## **Central Planning Authority**

**Agenda** for a meeting of the Central Planning Authority to be held on **April 27, 2022 at 10:00am** in **Conference Room 1038, 1<sup>st</sup> Floor, Government Administration Building, and Elgin Avenue.**

**CPA/12/22**

Figure 1: A terrestrial habitat map showing the subject parcel (outlined in blue) showing the man modified areas and the existing dry shrubland and forest (DOE, 2021).

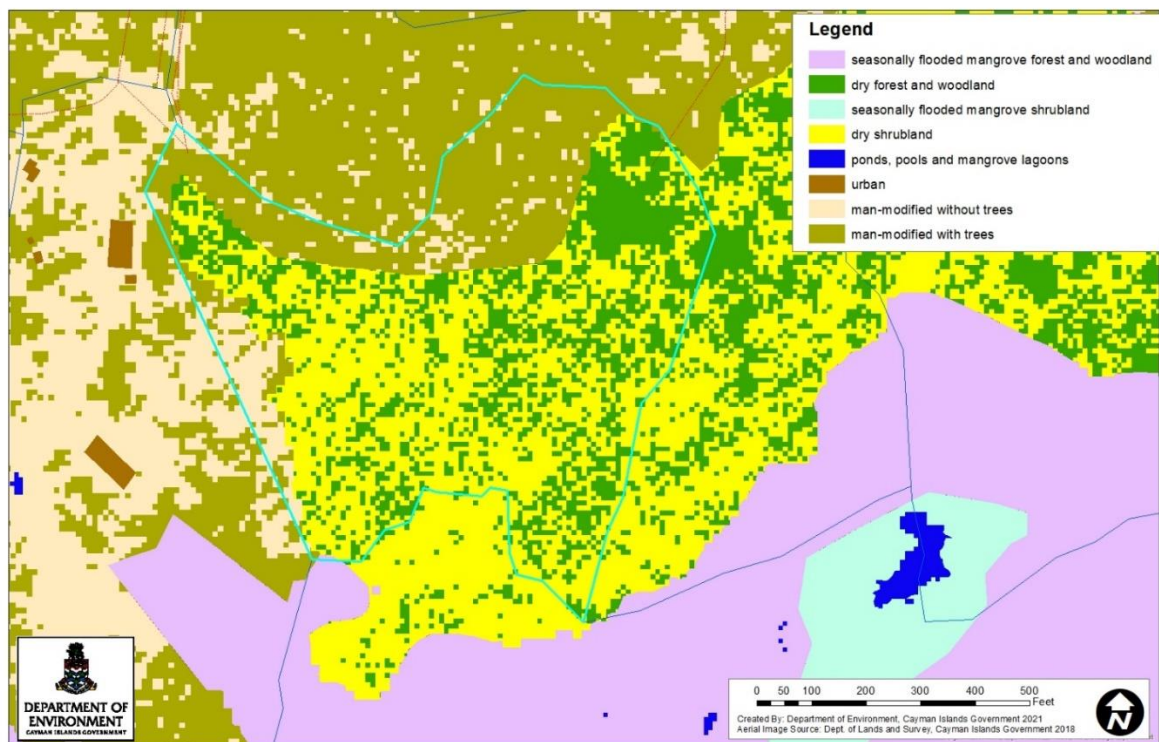
*The application site consists of a mixture of primary dry shrubland and forest habitat and man-modified areas as shown in figure 1 below. The parcel to the immediate south*

(65A/48) is owned by the National Trust of the Cayman Islands and is particularly ecologically important as it provides habitat for Blue Iguanas (*Cyclura lewisi*). Blue Iguanas are listed in Part 1 of Schedule 1 to the National Conservation Act, 2013, as being 'protected at all times' and are also listed as **endangered** on the IUCN Red List.

In order to reduce the risk of impact on the neighbouring National Trust parcel, the DOE recommends that the road parcel be shortened so that it does not reach the southern parcel boundary and that an uncleared buffer area of 50ft in width be retained along the southern parcel boundary adjoining 65A/48. DOE also strongly recommends that the building of the road and any clearing should not occur until development is imminent and that any future clearing, filling or development of the resulting parcels should be the subject of a separate consultation with the National Conservation Council.

In the future, should the land be brought forward for development, we would strongly recommend the installation of predator fencing to ensure that no domestic animals enter the nearby Salina Reserve, which would present a serious threat to the Blue Iguana population.

Figure 1. The terrain at the site, with a higher elevation ridge to the southeast of the application site.

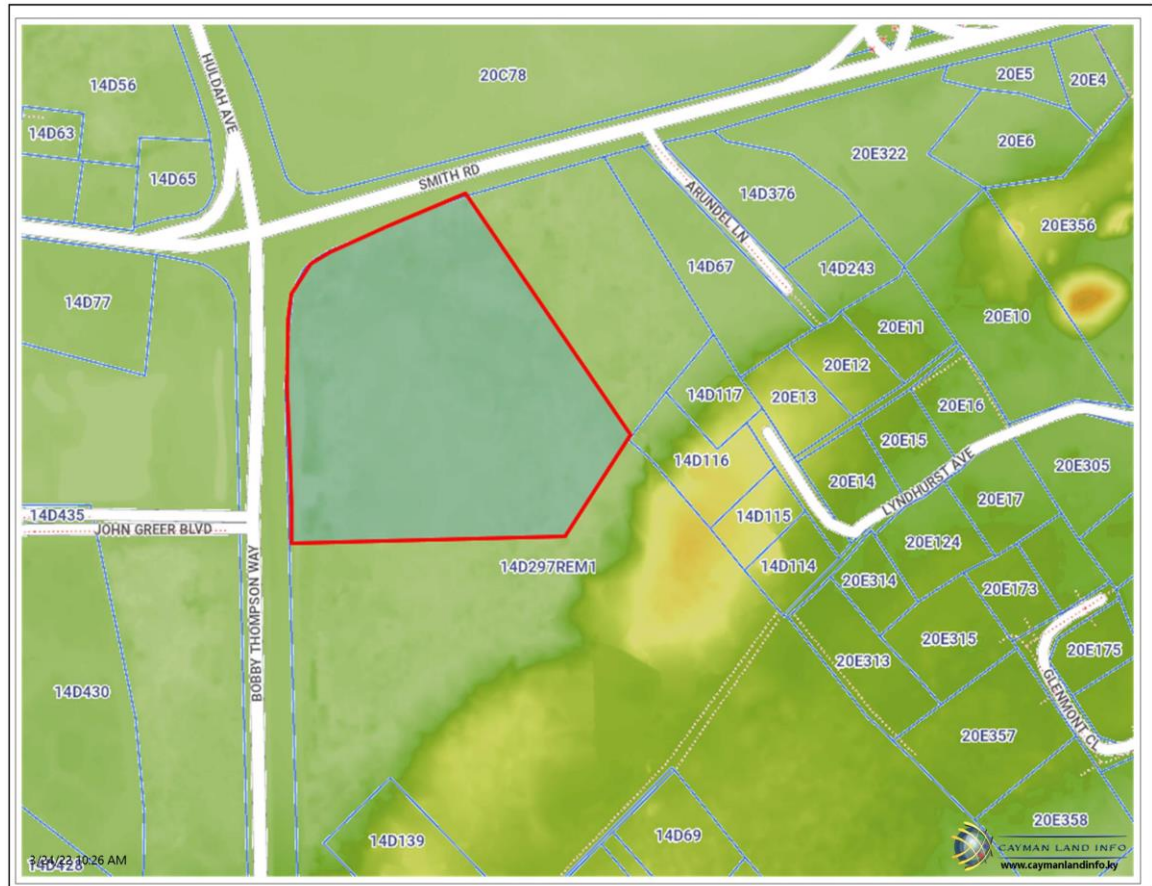
*The majority of the site is occupied by primary semi-permanently flooded grassland habitat. These freshwater grasslands are a diminishing habitat type in Cayman. According to the National Biodiversity Action Plan 2.T3.2, this habitat type is dominated by Bullrush (Typha) *Typha domingensis*. A clearing and filling application was submitted in January 2022 (P22-0055). We are encouraged to see that application (P22-0055) has been adjourned until this planning application for development (P22-0182) has been considered.*

*We note that the National Roads Authority is likely to have comments regarding entry and egress to the development given the proximity to a major intersection. We also note that the existing site has a low elevation and that there is a higher elevation ridge to the southeast of the application site (Figure 1). The habitat type (semi-permanently flooded grassland) indicates the presence of standing water and that the site likely receives surface water run-off from the surrounding area. Therefore, the reduction in drainage capacity caused by developing the Pickleball Club may cause or exacerbate flooding of the road and surrounding area.*

*Should the Central Planning Authority or Planning Department be minded to grant planning permission for the development, the DoE recommends the following:*

- *A stormwater management plan is prepared for the site to mitigate against the inundation of the surrounding area. We also recommend the use of permeable court and paving solutions to aid in stormwater management.*
- *No clearing and/or filling shall take place until planning permission for the development has been granted and the development of the Pickleball Club is imminent.*
